ADDENDUM

Renovations to:
Landfall Dye Clubhouse

ADDENDUM #2

Renovations to
The Country Club of Landfall
Dye Club House
Wilmington, NC 28405

1 / EL1.1 **FIRST FLOOR PLAN**
scale: 3/16"=1'-0"

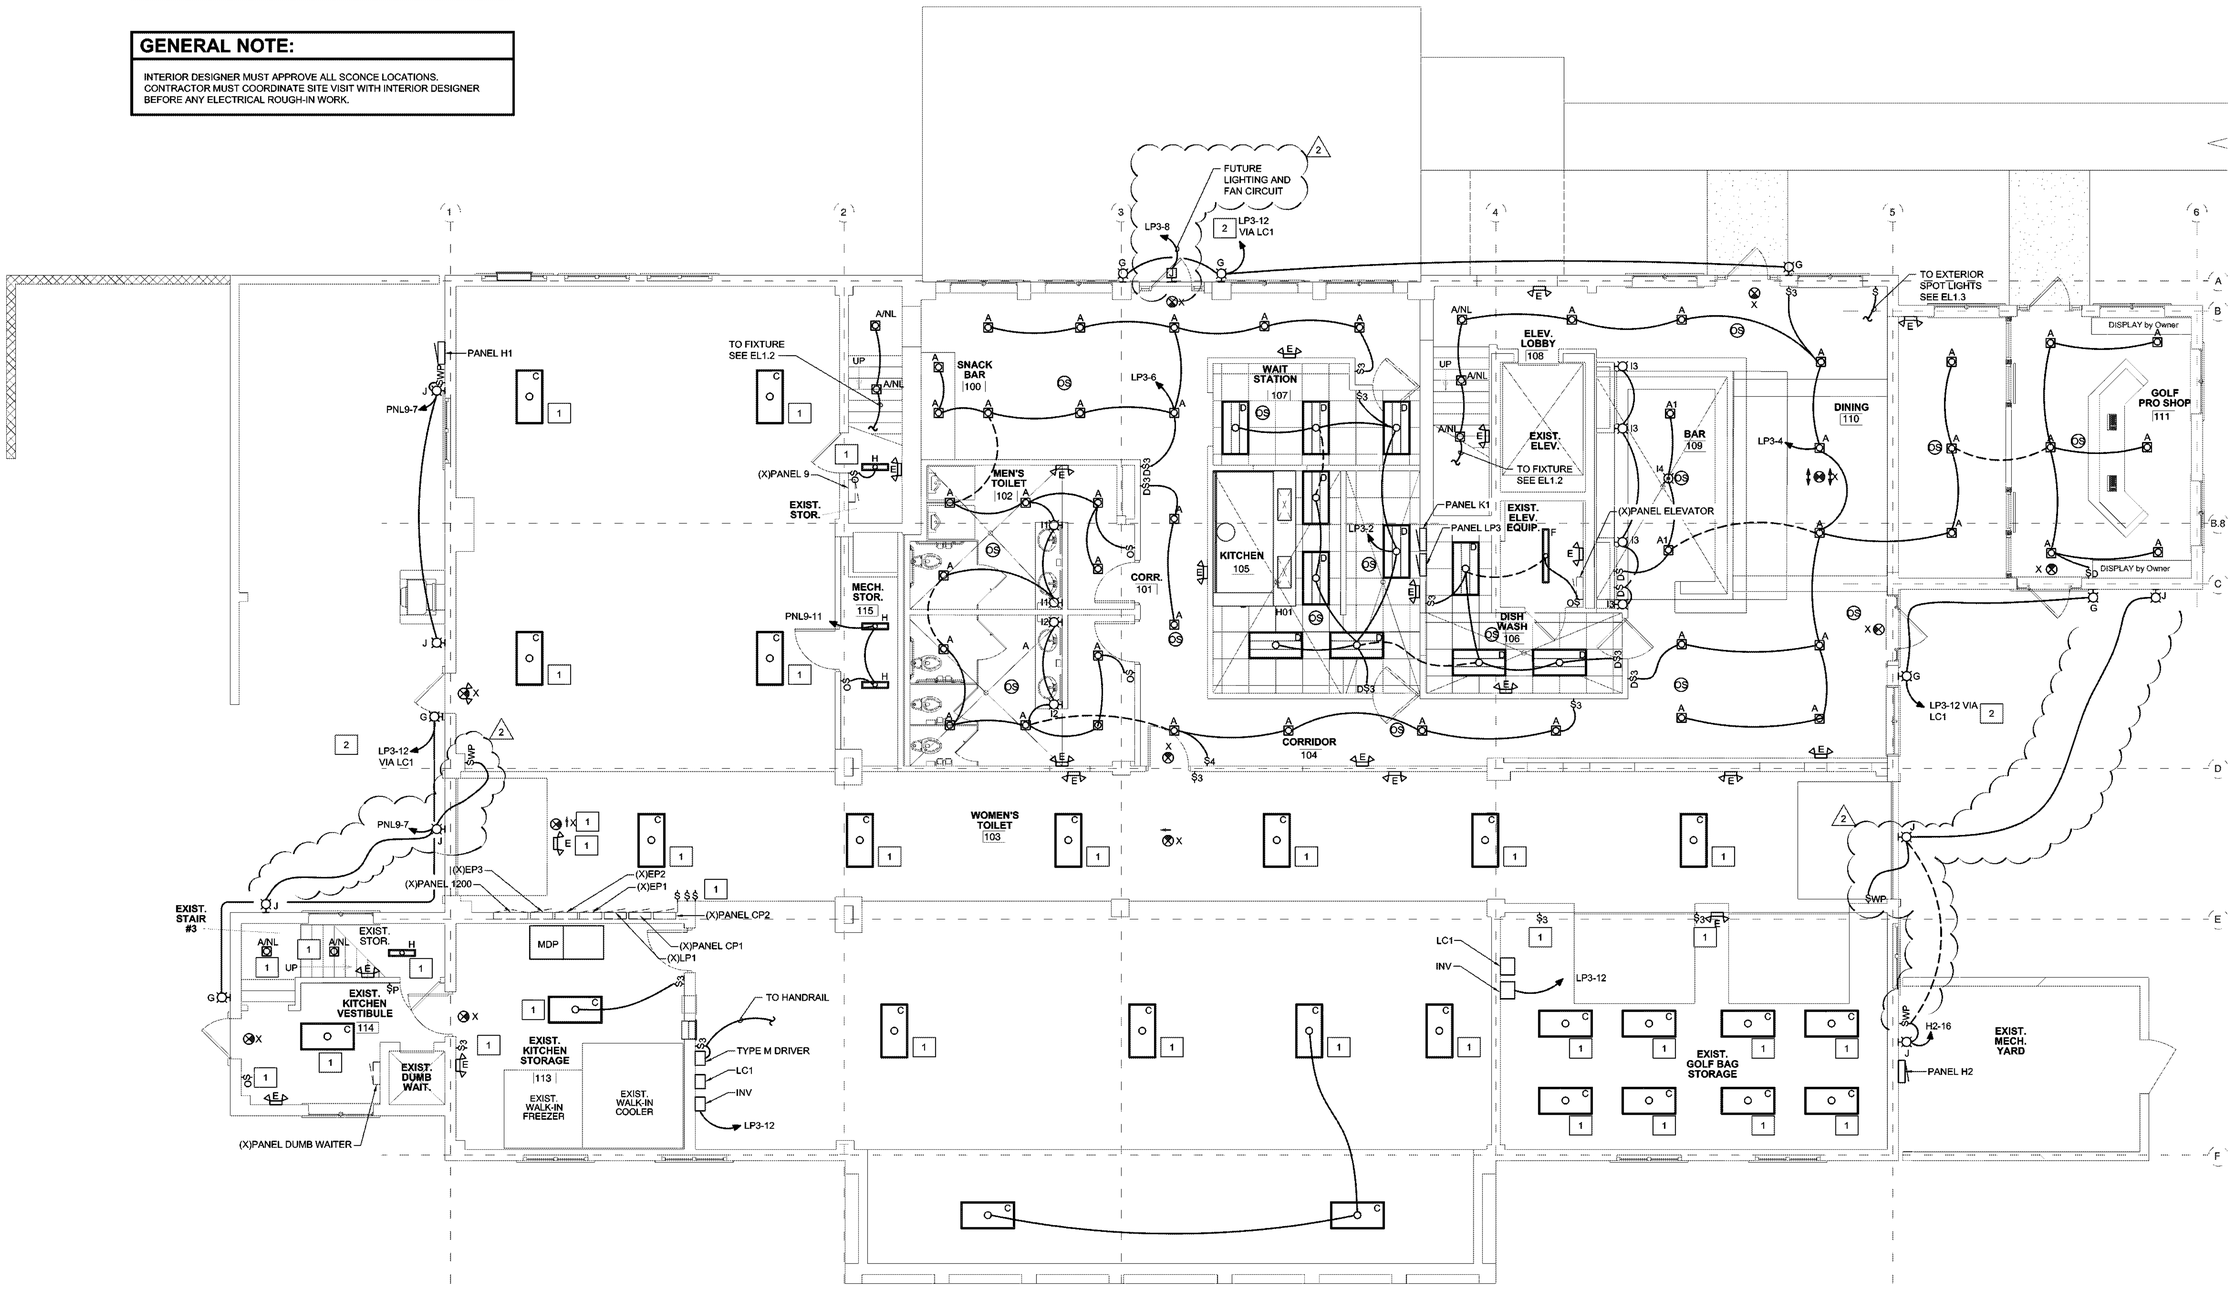
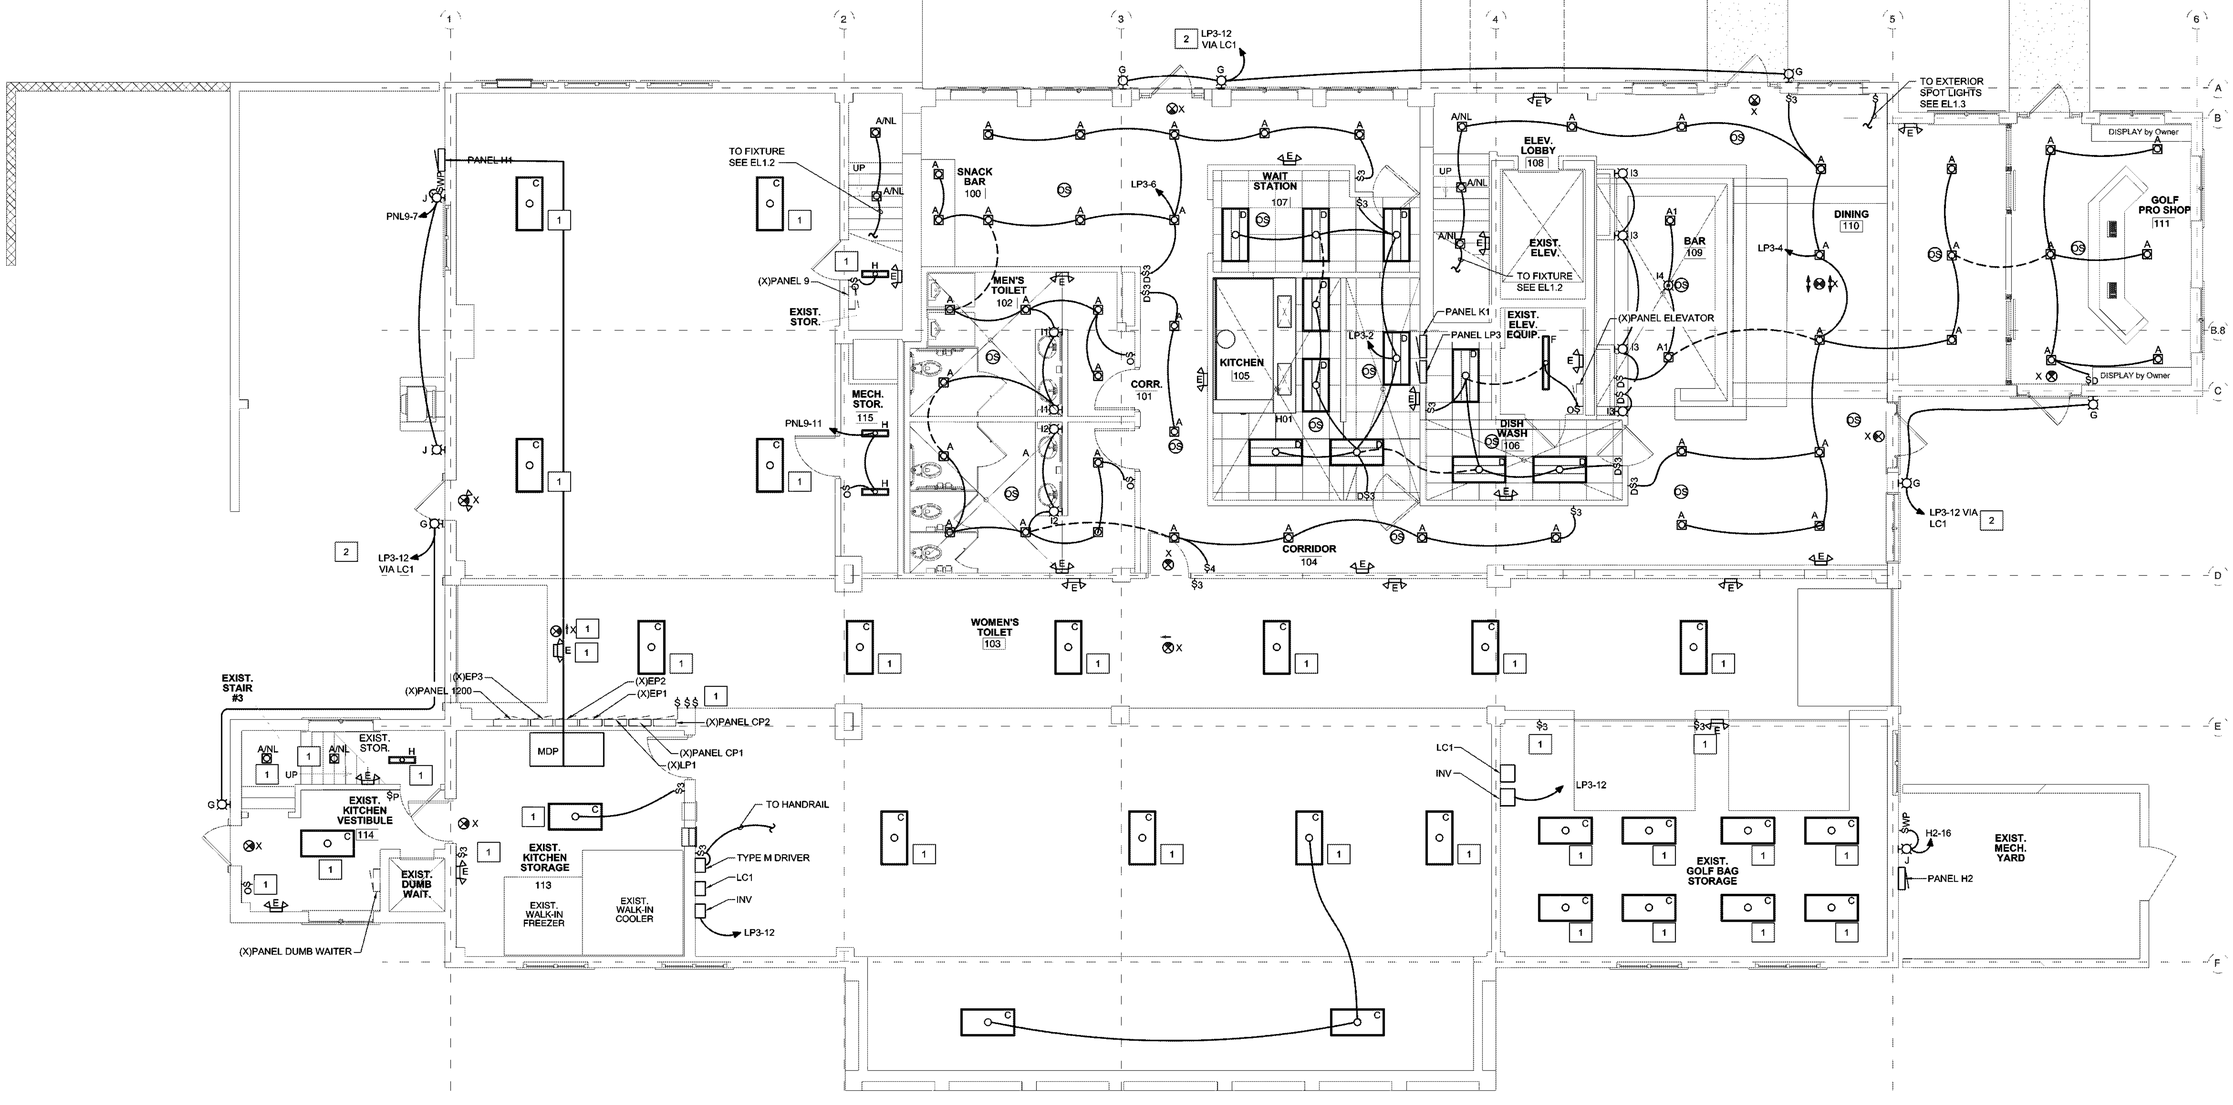
Various The architectural, electrical and mechanical sheets have been revised to reflect aesthetic alignment of diffusers and lights. A flat section of ceiling has been added to the second floor dining room. The fixture count went down by 2, one on each floor. A dimmer was added to the area that opens into Main Dining Room for 2 can lights. Reference reissued sheets A7.0, A7.1, EL1.1, EL1.2, M1.1, M1.2. Reference Addendum #1 included as **attachment #1**.

Item 4 ASI #4 has been previously issued and contains the following revisions. Multiple electrical sheets were reissued following owner directed revisions to low voltage and other electrical items. Reference ASI #4 included as **attachment #5**.
